**MONTGOMERY COUNTY PLANNING DEPARTMENT**  
THE MARYLAND-NATIONAL CAPITAL PARK AND PLANNING COMMISSION

**REVIEW TYPE:** Preliminary Plan of Subdivision

**PROJECT NAME:** Kensington Heights

**CASE #:** 120080250

LIBER 33451 / FOLIO 643  
**KENSINGTON HEIGHTS**  
 WHEATON (18TH) ELECTION DISTRICT  
 MONTGOMERY COUNTY, MARYLAND  
 PRELIMINARY PLAN

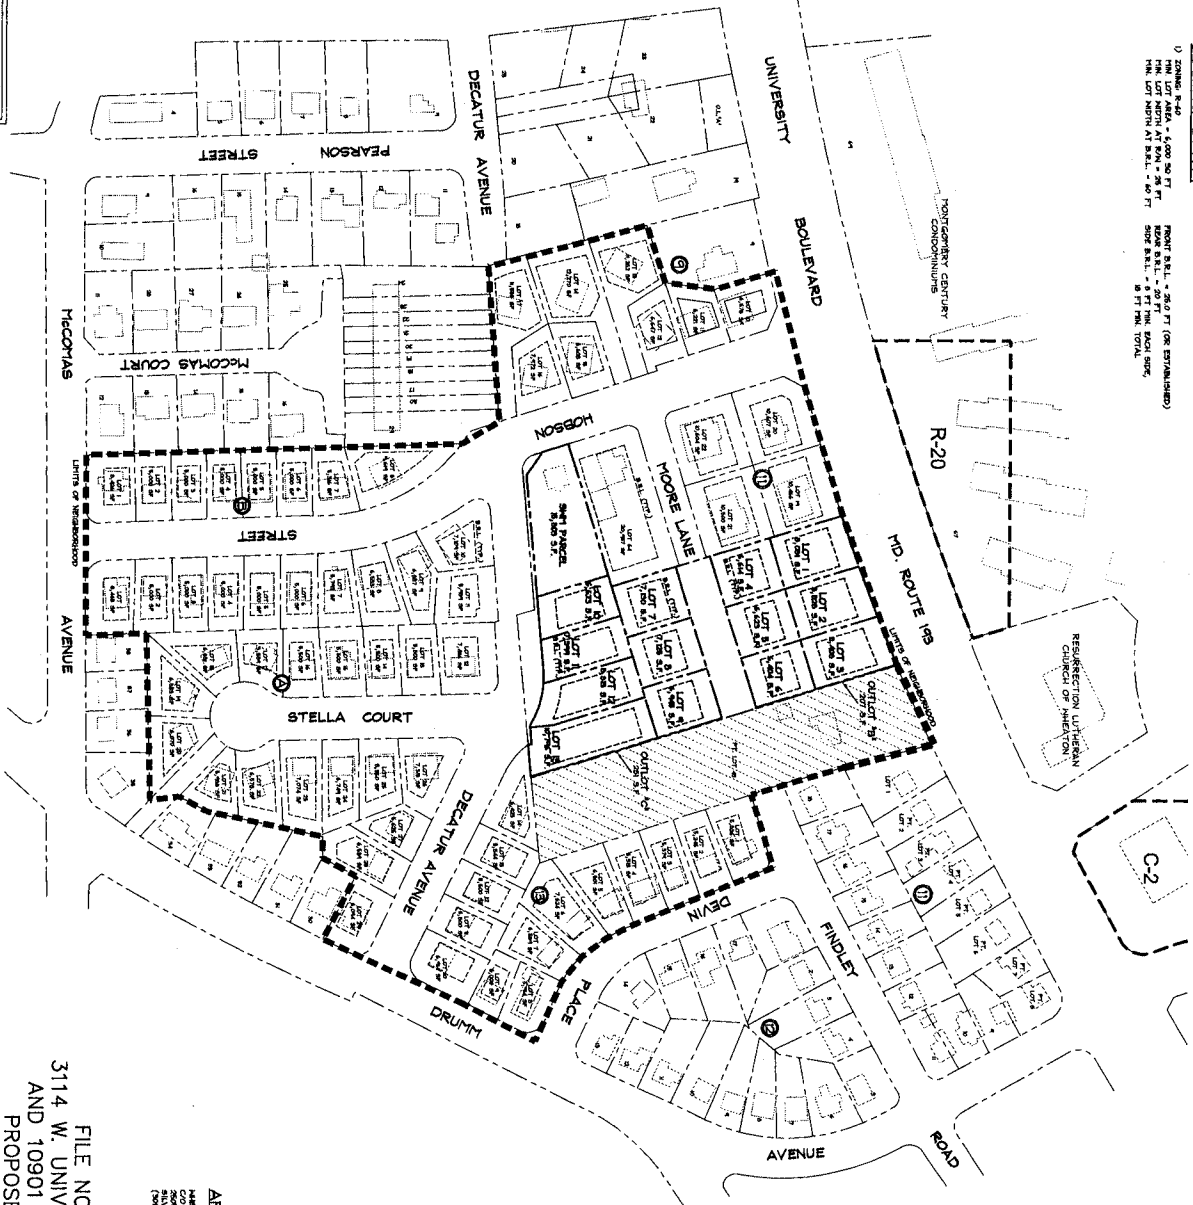
The applicant proposes to resubdivide the subject property into 13 lots for 13 one-family detached dwellings. The lots will range in size from 6,404 to 10,768 square feet. The proposal includes an extension of Moore Lane from its current terminus at the subject property's western boundary, through the property to a hammerhead turnaround at the eastern boundary; and an extension of Decatur Avenue from its current terminus at the intersection of Stella Court, along the southern property boundary to Hobson Street. Approximately 11,500 square feet of the subject property will be dedicated for right-of-way for the extension of Moore Lane and approximately 5,650 square feet of the subject property will be dedicated for right-of-way for the extension of Decatur Avenue. Three lots will front on University Boulevard, six on a proposed extension of Moore Lane, and four on Decatur Avenue, including its proposed extension. The lots fronting on University Boulevard will have driveway access from the extension of Moore Lane. The majority of lots will be accessed by individual driveways, but four lots on Moore Lane will share a single driveway and two lots on Decatur Avenue will share another driveway. A 15,800 square-foot stormwater management parcel (which will contain an underground stormwater management structure) is proposed in the northeast quadrant of the intersection of Hobson Street and Decatur Avenue. Two outlots are proposed, each of which will be one foot wide. These are intended to be transferred to the adjacent property to the east in the event that it is subdivided in the future. The long narrow strips are needed for the adjacent property to reach a width of 120 feet – the minimum width of two lots in the R-60 zone.

Vehicular access to the proposed lots will be provided by individual and/or shared driveways from the proposed extensions of Moore Lane and Decatur Avenue. Pedestrian access will be provided by proposed sidewalks on Moore Lane, Decatur Avenue, and Hobson Street. The existing sidewalk on University Boulevard is proposed to be reconstructed to be six feet wide.

The lots were reviewed for compliance with the dimensional requirements for the R-60 zone as specified in the Zoning Ordinance. The lots as proposed will meet all the dimensional requirements for area, frontage, width, and setbacks in that zone. A summary of this review is included in attached Table 1. The application has been reviewed by other applicable county agencies, all of whom have recommended approval of the plan.

- 6) The applicant must construct sidewalks as shown on the preliminary plan as follows:
  - a. Reconstruct the sidewalk along the property frontage on University Boulevard to be six feet wide, located two feet from the property line and including a landscape panel with street trees between the curb and the sidewalk.

- b. Construct a five-foot-wide sidewalk on the north side of the proposed Moore Lane extension.
  - c. Construct a five-foot-wide sidewalk on the north side of the proposed Decatur Avenue extension.

- d. Construct a five-foot-wide sidewalk on the east side of Hobson Street between Decatur Avenue and Moore Lane.
  - e. Provide at-grade sidewalk crossings of the driveways on Moore Lane and Decatur Avenue.
